IN THE DRAWINGS

Replacement Sheet

FIG. 1

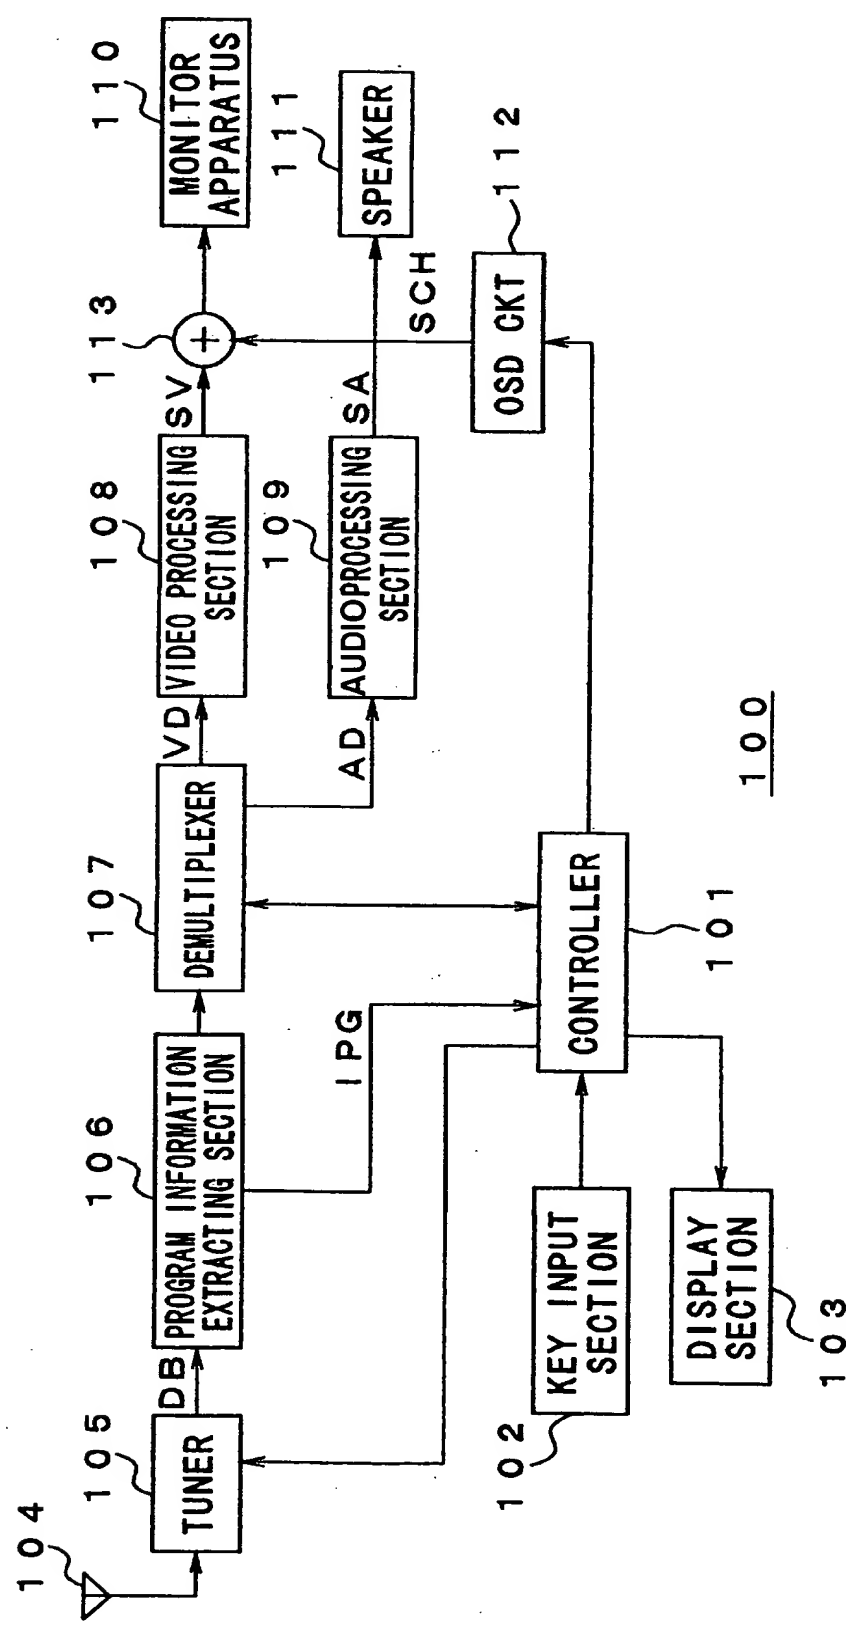
Fig. 1, element 109 has been amended to include the label “AUDIO PROCESSING SECTION”.
